AMENDMENT, REVISED ENTIRE DRAWING	7/2/03	JWW
Symbol	Date	Appr

CORROSION CONTROL FACILITIES, PHASE 1
DEMOLITION CORROSION CONTROL HANGARS (VOL. 2)
PROJECT NUMBER PR044500P1
MCCONNELL AFB, KANSAS

FIRE PROTECTION DEMOLITION
AND NEW WORK PLAN
BUILDING 1176

Sheet reference number:
D_FD105

1 FIRE PROTECTION DEMOLITION AND NEW WORK PLAN, BUILDING 1176
SCALE: NONE

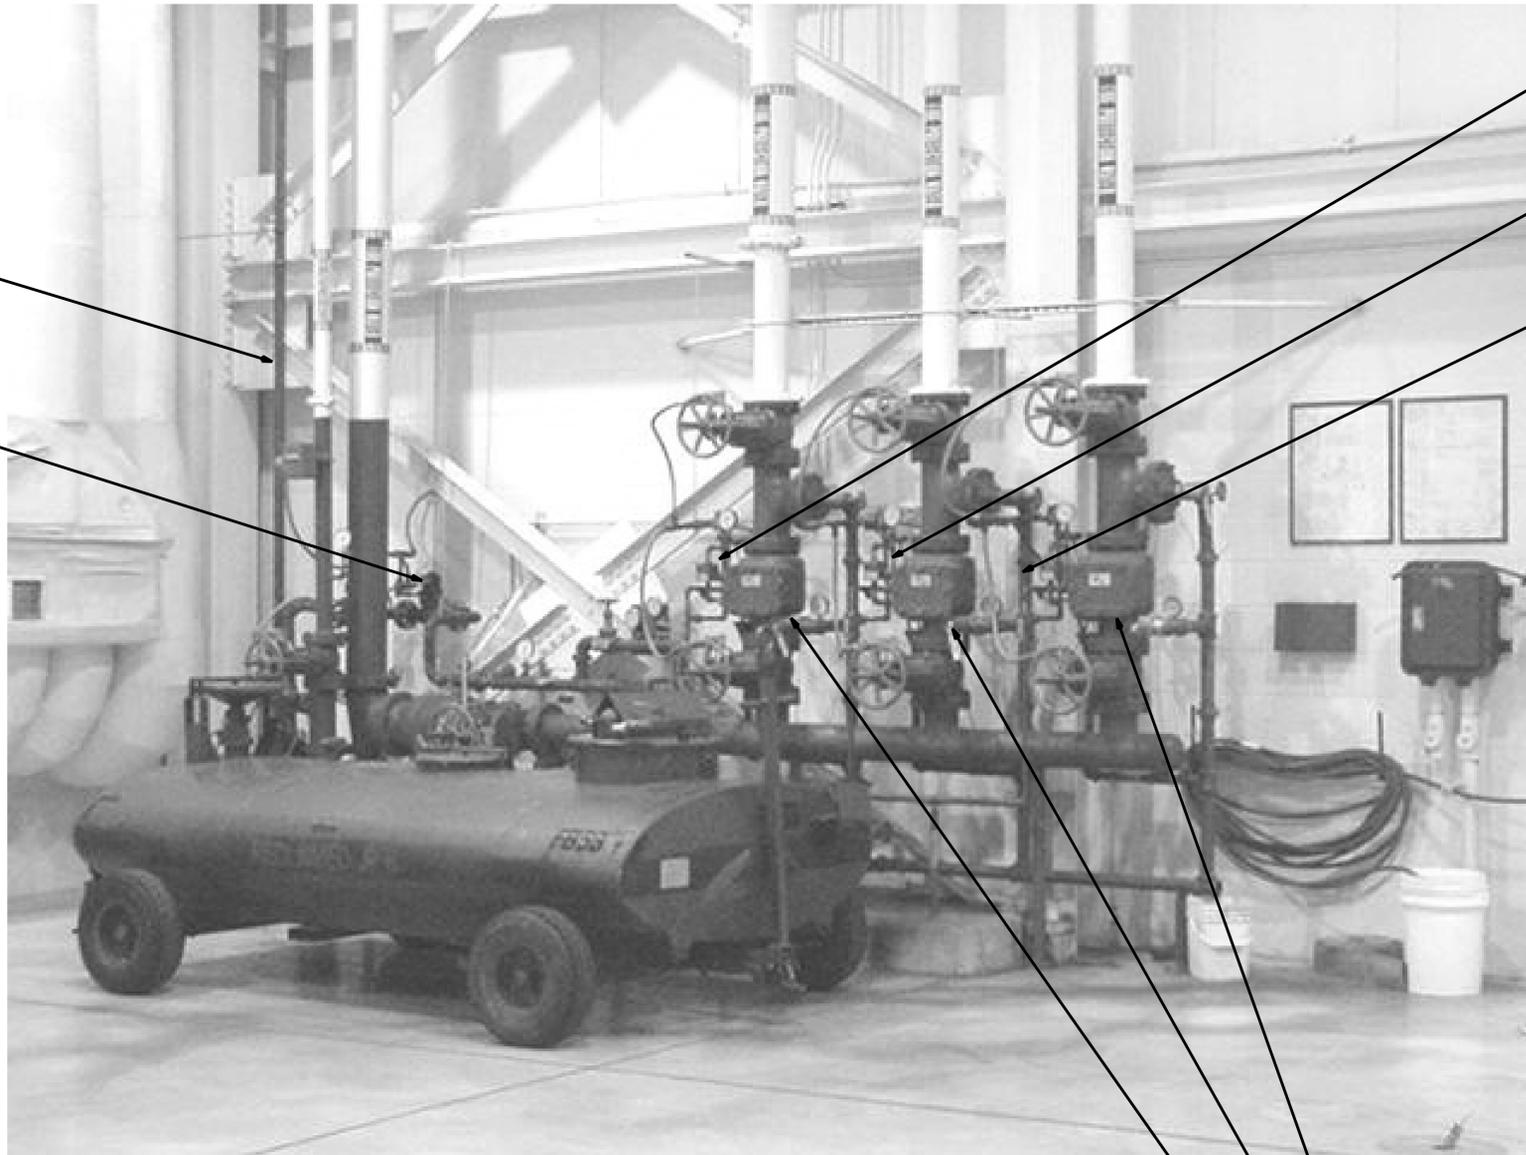
REMOVE AFF CONCENTRATE PIPE

REPLACE MAGNATROL SOLENOID VALVE
